Thoughts on the 100GbE Proposed PCS changes

802.3bm

Introduction to the problem

Full Span Problem

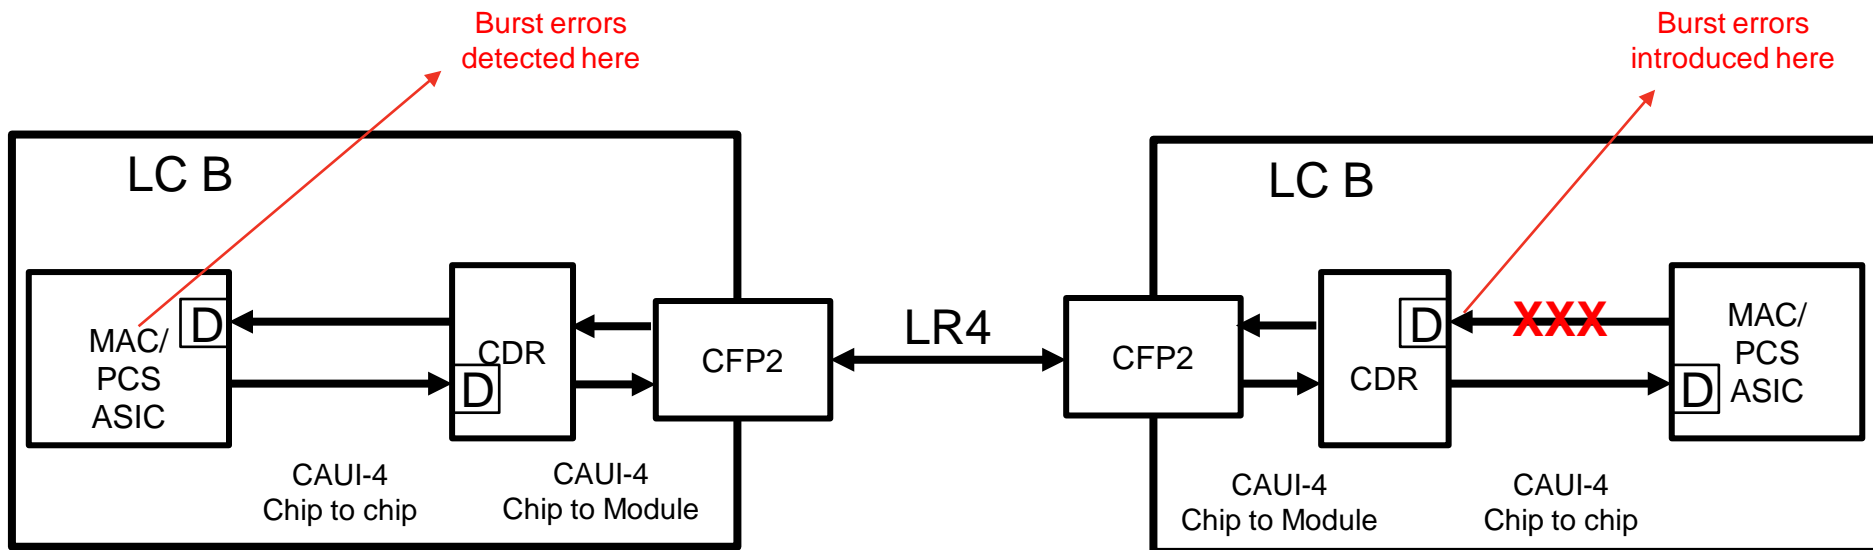
- If both sides have a CAUI-4 interface then how would you know which linecard to replace?
 - Assuming the desired action is to replace a card? That is otherwise compliant but happens to get a burst errors?
 - You cannot put LCs into loopback and reproduce this problem in a reasonable timeframe
- Or you add a requirement that retimers monitor the BIP!
 - This would part of the PCS into the PMA
